780 BLANSHARD - REHABILITATION + ADDITION

HAV00034 CONCURRENT WITH REZ00825

Bubbled areas indicate revisions compared to the previously submitted plans

DATE	REV	ISSUE DESCRIPTION
2022-02-24	1	REZONING PRE-APPLICATION
2022-06-01	2	OPEN HOUSE PROGRESS SET
2022-06-21	3	REZONING APPLICATION
2023-03-23	4	HAP & REZONING RESUBMISSION

A015

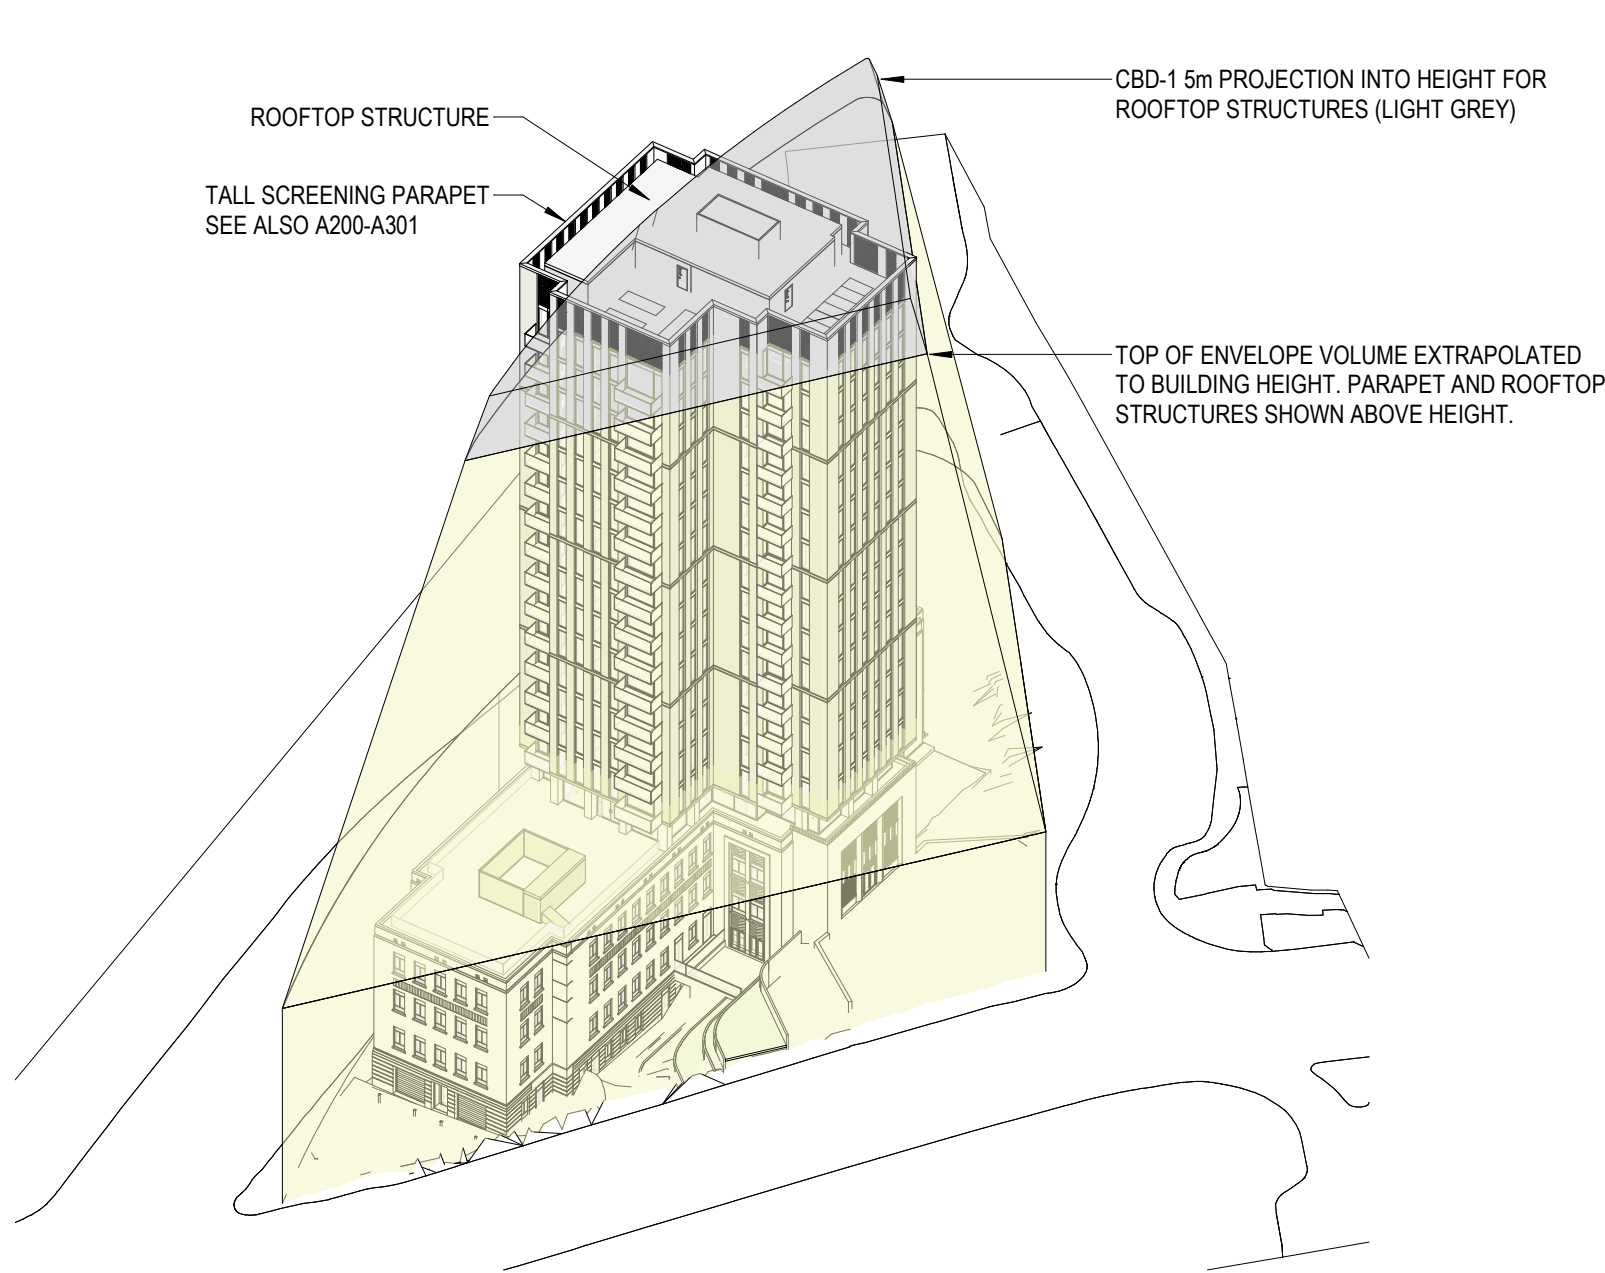
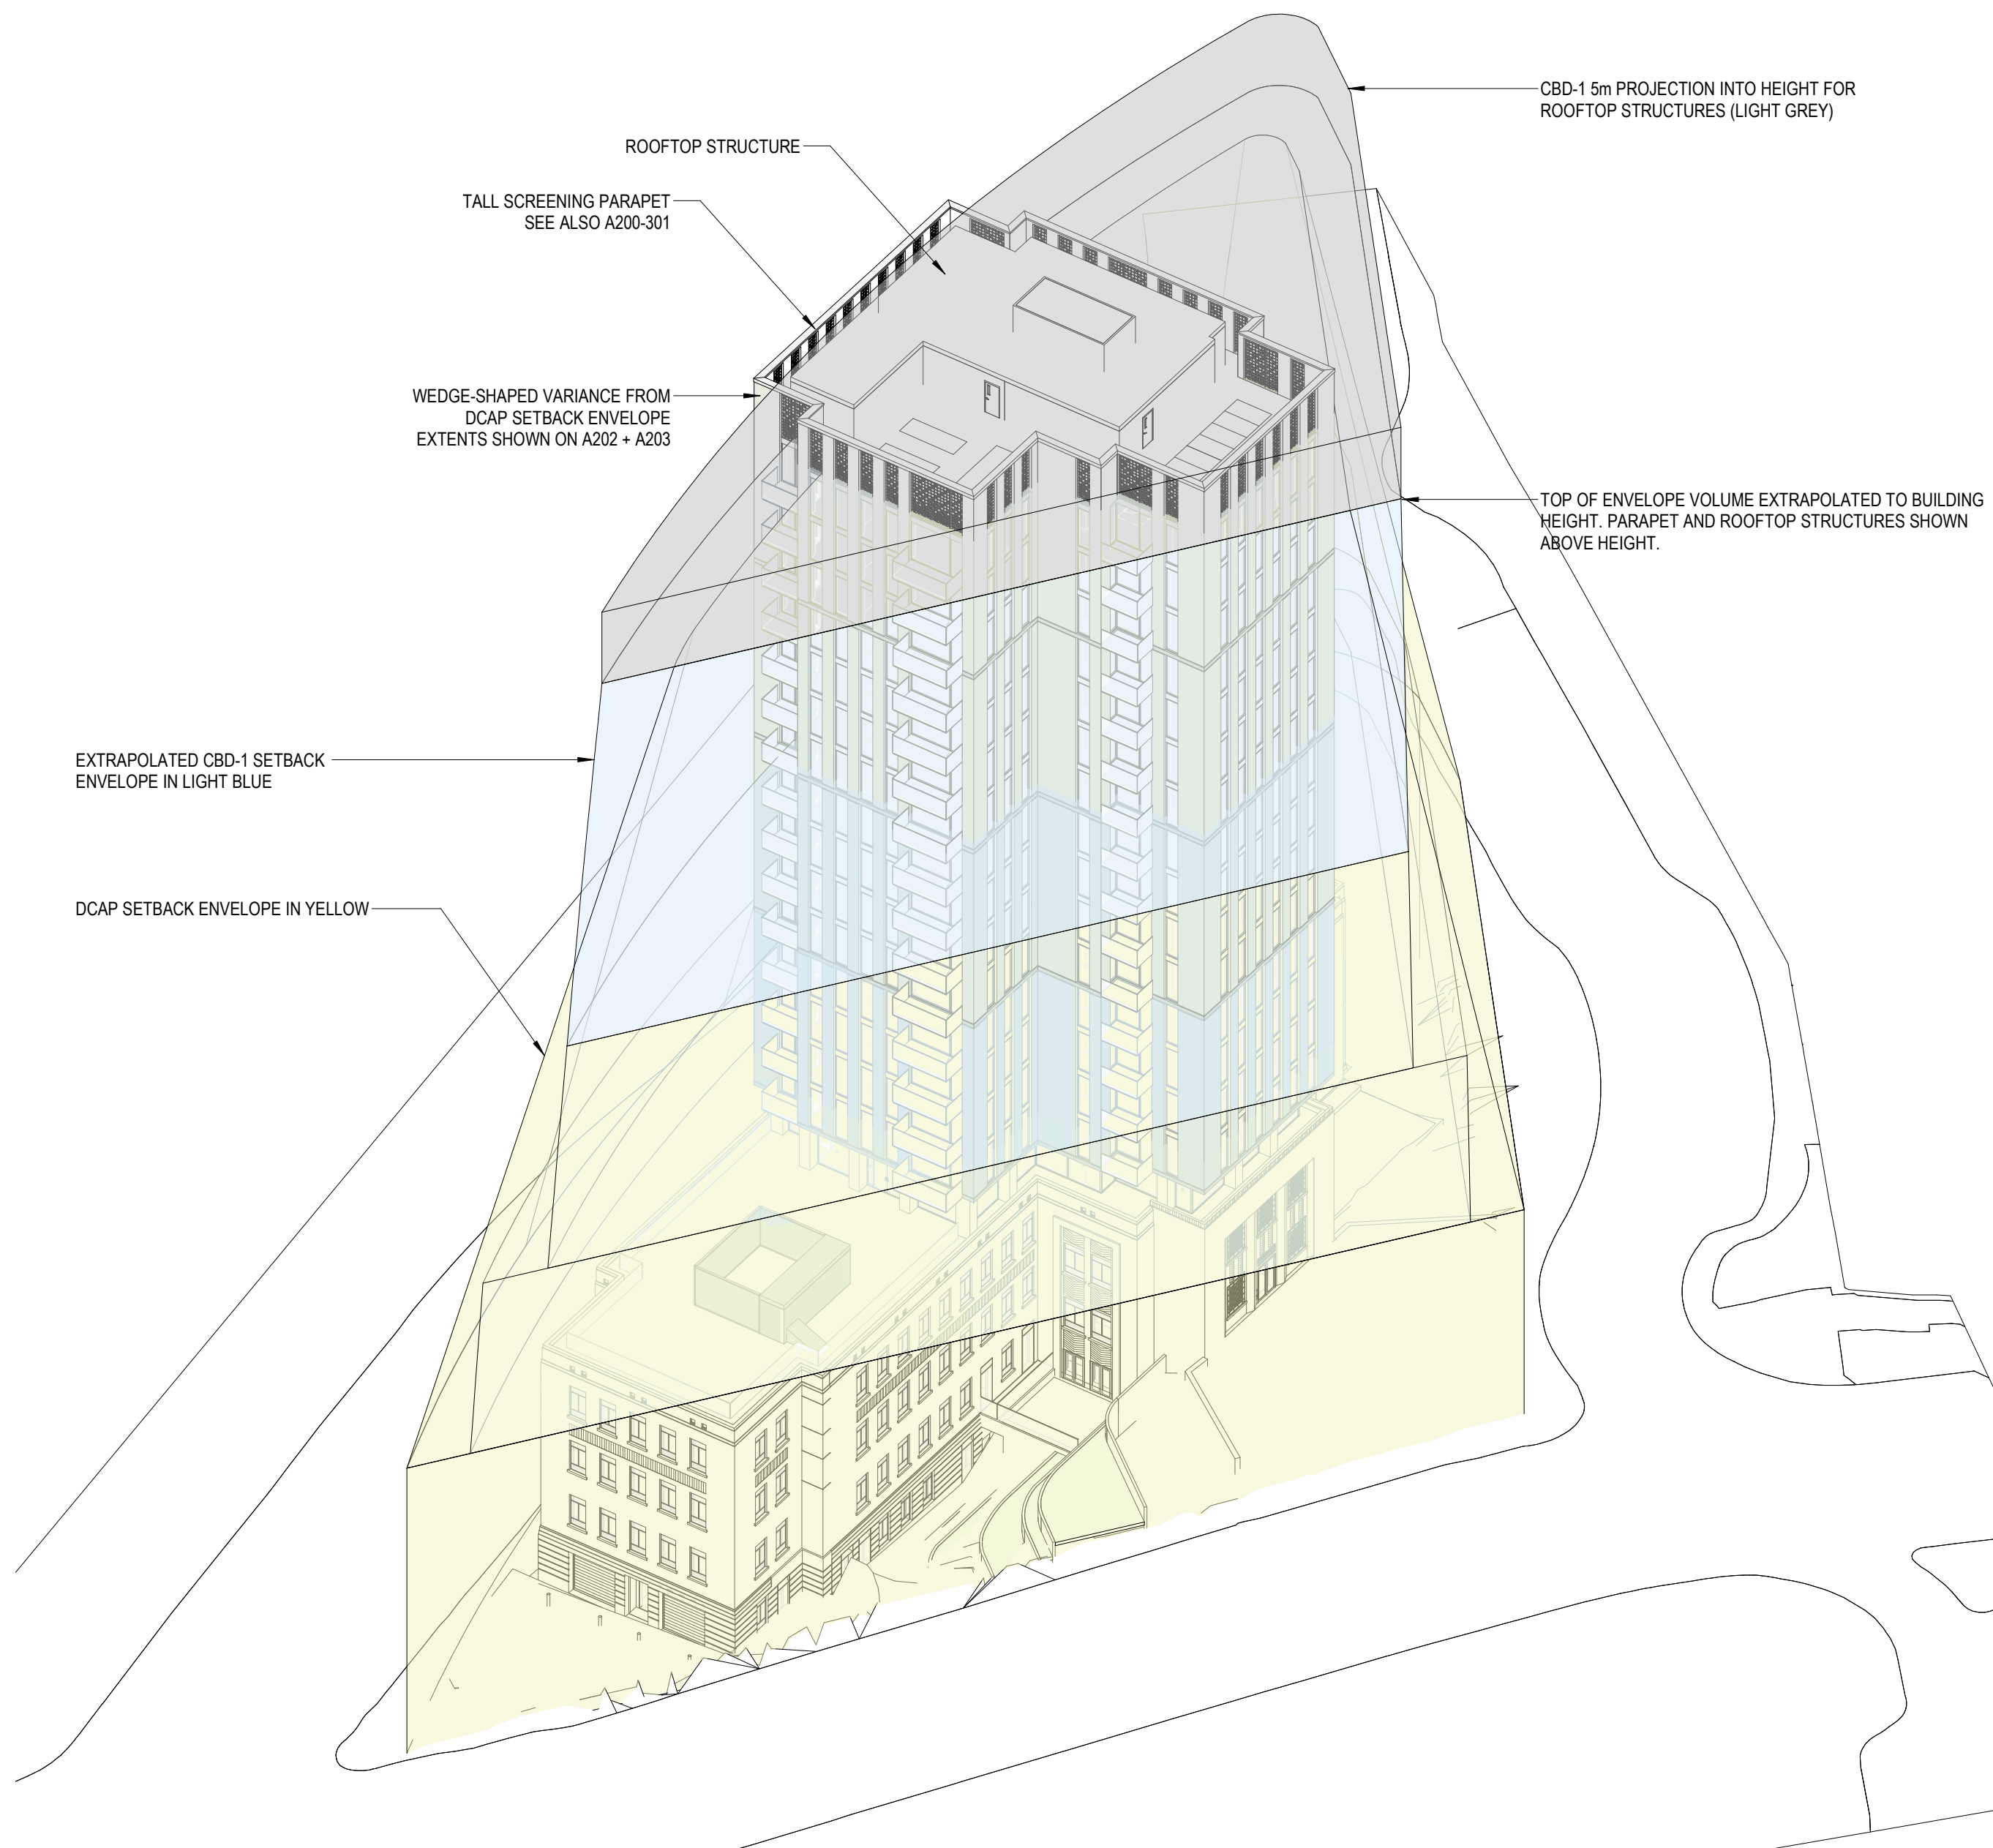
16 Zoning envelope diagrams updated with shorter revised massing developed in response to ARS Comment #22.
